# Certificate of Appropriateness

1851 N. 2ND ST.      Brewers Hill HD

5/11/2018      PTS ID 114437 COA: rehab house, demo garage

SHEET TITLE  
**FLOOR PLANS**  
 SHEET NUMBER  
**A101**

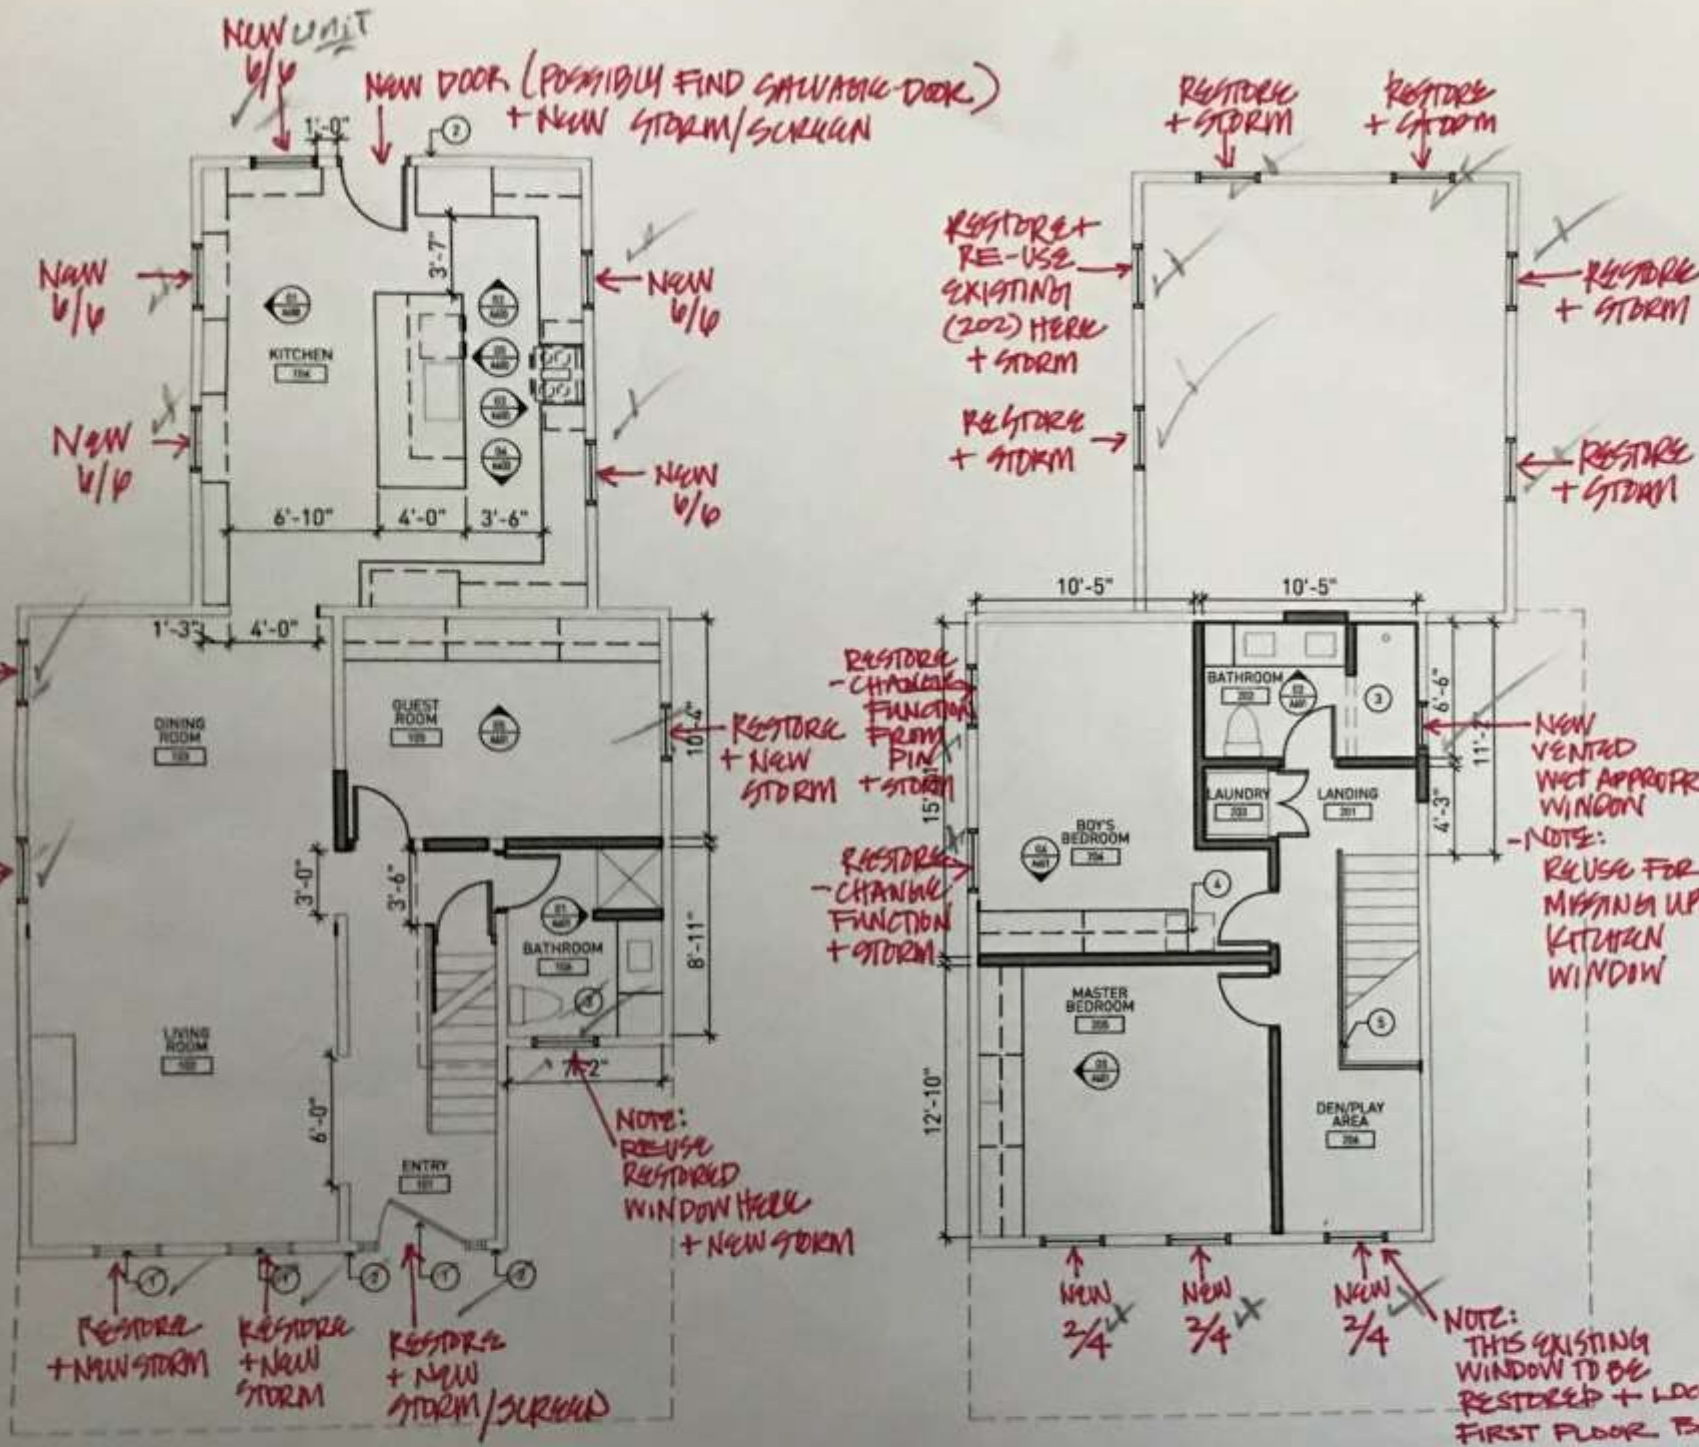
1. Repair and tuckpoint foundation and any other brick surfaces.
2. Repair, replace, and add additional windows (per attached specs). All muntins for replacement and new windows shall be based on surviving pre-1900 windows. See annotated Tredo Sheet A101 and notes on east elevation below. New wood-framed storms/screens for all windows. New wood rear door (p. 10).
3. Fixtures: Rejuvenation upright sconces in black (p. 9). Plain flat-bar type handrail where required by code. Brass door hardware (p. 10).

- E1. Replace all three second-floor windows with two-over-four sash to imitate the one remaining historic window. Option to keep and repair northernmost window on this floor.
- E2. Replace "parson's door" with any of the following:
  - 6/6 window,
  - 2/4 window relocated from second floor or new replica
  - 2/2 window new, double hung, to match muntins and pane heights of casement windows on this elevation.

Other Fenestration: See A101

New mortar must match the original mortar in terms of color, texture, grain size, joint width, and joint finish/profile. The compressive strength of the repointing mortar shall be equal or less than the compressive strength of the original mortar and surrounding brick or stone. The replacement mortar shall contain approximately the same ingredient proportions of the original mortar. Mortar that is too hard is subject to premature failure and could damage the masonry. See the city's books *As Good As New* or *Good for Business, Masonry Chapters*, for more information. In most cases this means a lime mortar with natural hydraulic cement rather than Portland cement. No joint of a width less than 3/8" may be cleaned of damaged/decomposed mortar with power disc grinders. No over-cutting of the joints is permitted. Remove decomposed mortar back into the wall 2.5 times the height of the joint before tuckpointing.
